DEVELOPMENT REVIEW COMMITTEE (DRC) COMMENT REPORT

PROJECT NAME: 3600 Mixed Use

CASE NUMBER: UDP-PRE20002

REQUEST: Preliminary Site Plan Level Review: Conditional Use for a Mixed-Use Development with 33,400 Square Feet of Office Use, 4,500 Square Feet of Retail Use, Allocation of 53 Residential Flex Units, and 22 Residential Units

Public Plaza Examples: Comment #5

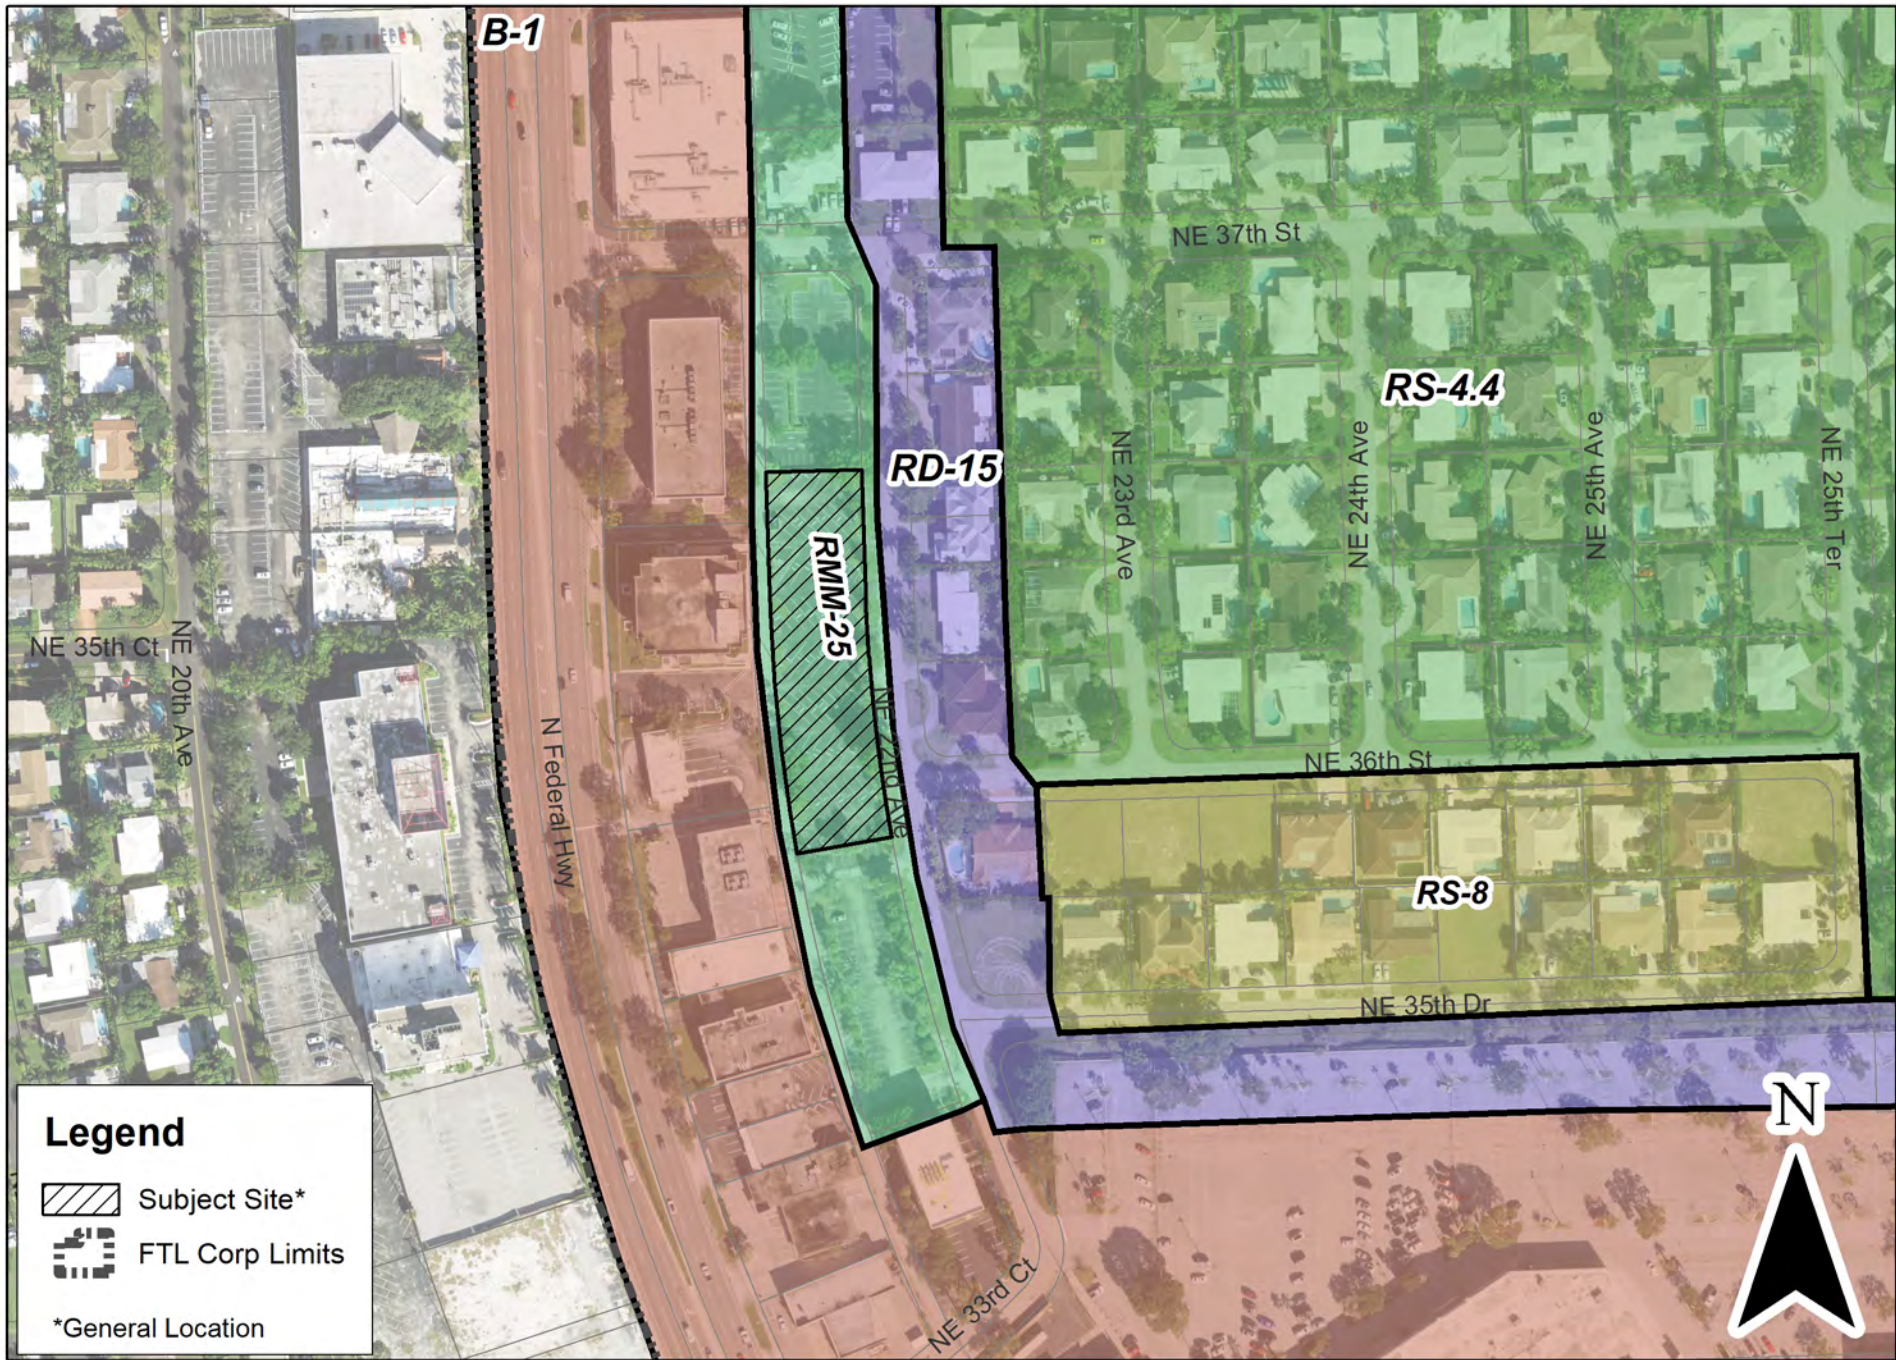
- 5) Pursuant to Section 47-18.21, Mixed Use Development, public plaza requirement. The proposed plaza does not meet the requirement as the location is disengaged from the coach homes in the rear and does not seem to encourage pedestrian friendly activities between both parcels of this entire development. Plaza elements should include (but are not limited to) pedestrian amenities such as landscaping, benches and fountains. The proposed retail plaza does not meet the intent of this section. (See images of some examples at the end of this document).
